Y/87/14/PL

PLAN-007970

Proposal: Additional use of premises for MOT testing (B2 General Industry).
Site: Unit 4, Glebelands Farm, Yapton Road, Barnham, PO22 0BJ.
Y/87/14/PL

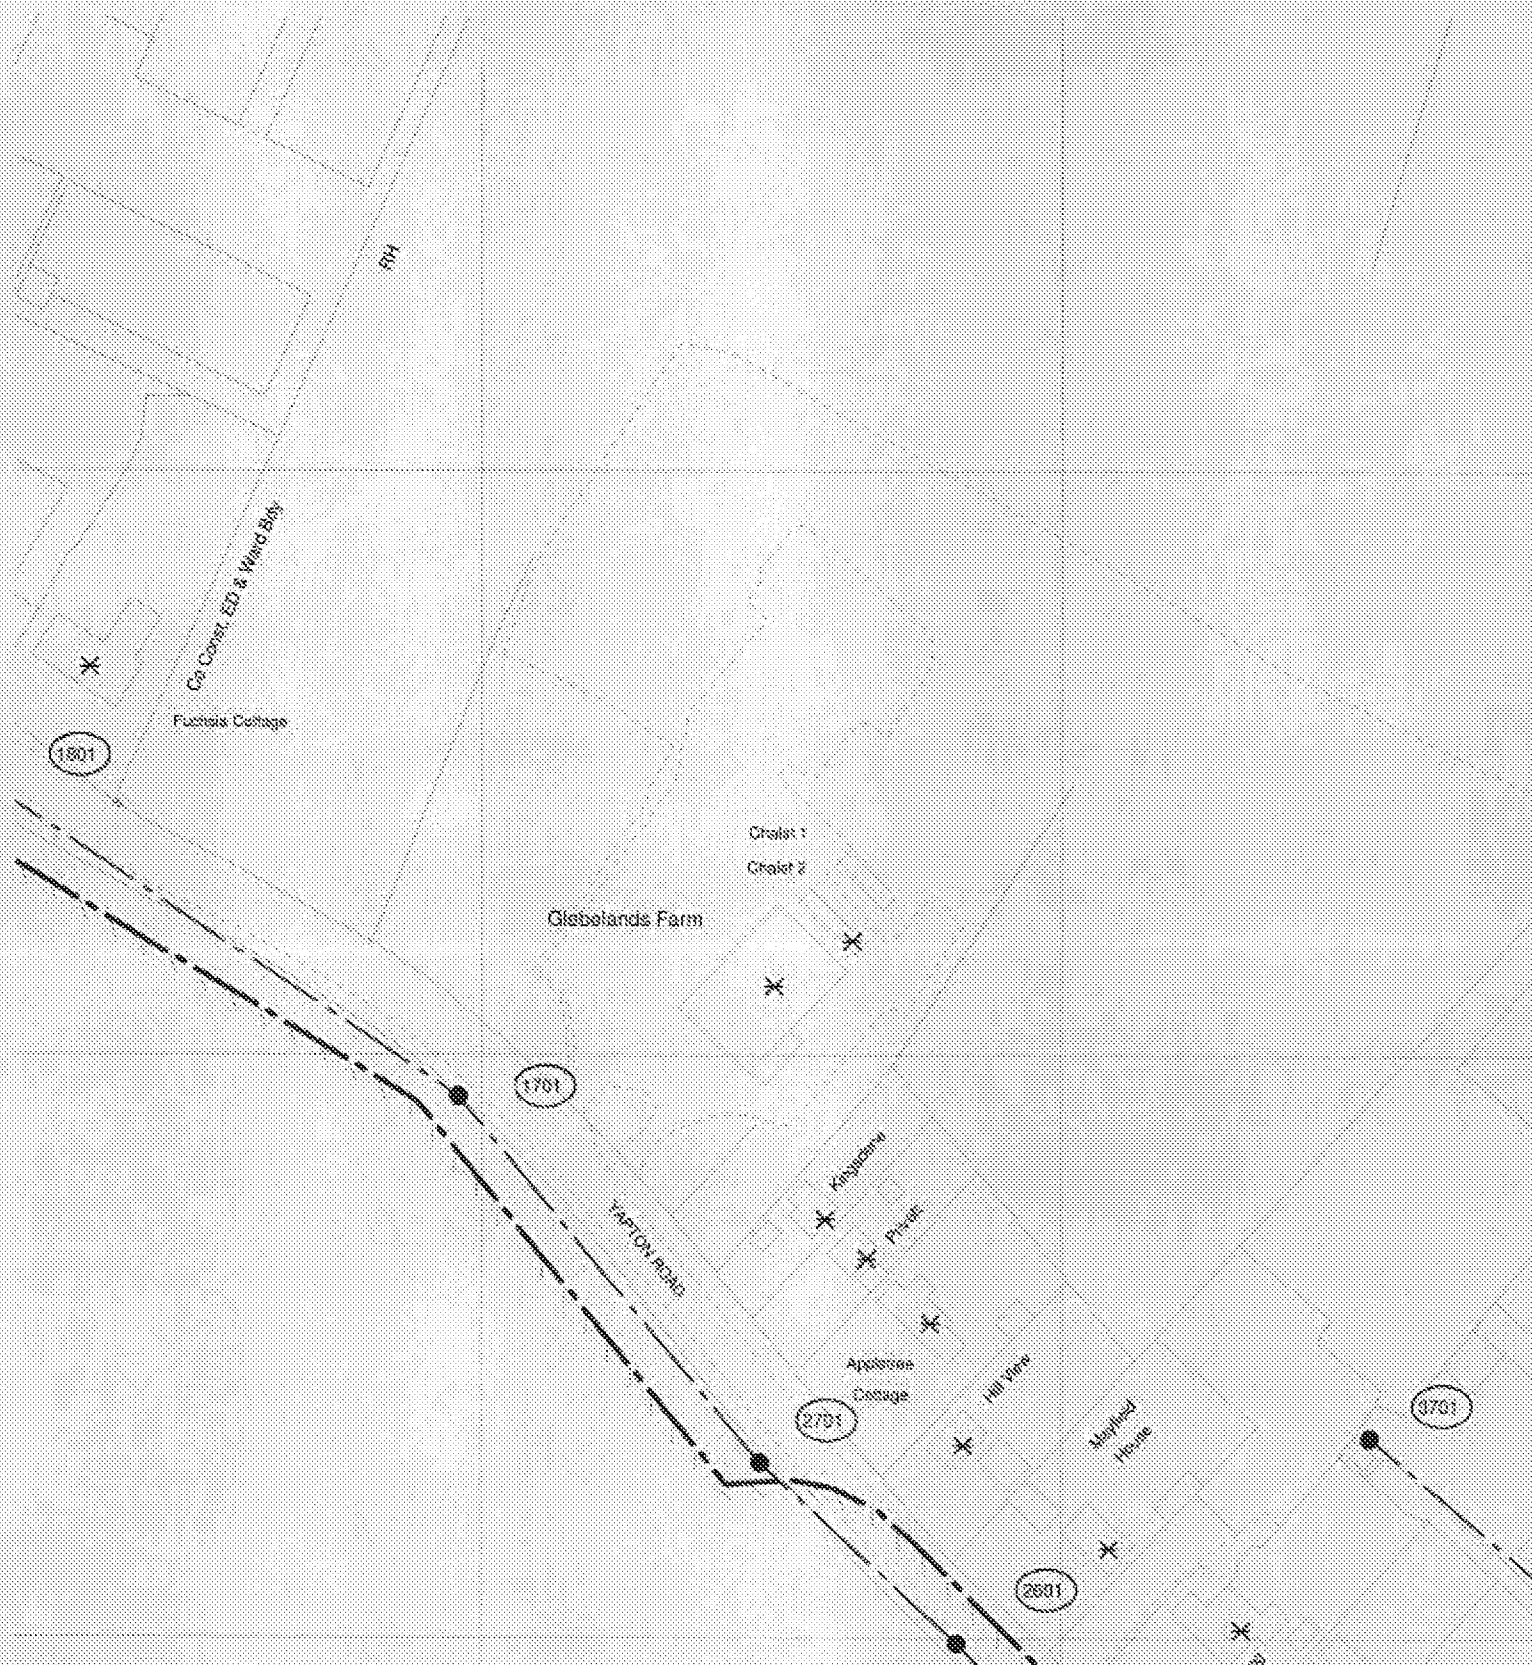
The applicant is advised to consult the Environment Agency directly regarding the use of a septic tank drainage which disposes of effluent to sub-soil irrigation. The owner of the premises will need to maintain the septic tank to ensure its long term effectiveness.

It may be possible for the flows from the proposed development to be connected to a nearby public sewer, and the applicant may wish to investigate this option. Southern Water requires a formal application for a connection to the public sewer. The applicant is advised to contact Southern Water, Sparrowgrove House, Sparrowgrove, Otterbourne, Hampshire SO21 2SW (Tel: 0330 303 0119) or www.southernwater.co.uk.

Due to changes in legislation that came in to force on 1st October 2011 regarding the future ownership of sewers it is possible that a sewer now deemed to be public could be crossing the above property. Therefore, should any sewer be found during construction works, an investigation of the sewer will be required to ascertain its

Due to surface water inundation issues in the Lidsey Catchment "The applicant is advised to adopt, where appropriate, the measures in the table "Practical measures to reduce the potential impacts of development".

Developer should look to protect the public sewerage system from inundation and infiltration, which contribute to flooding in unfavourable conditions.
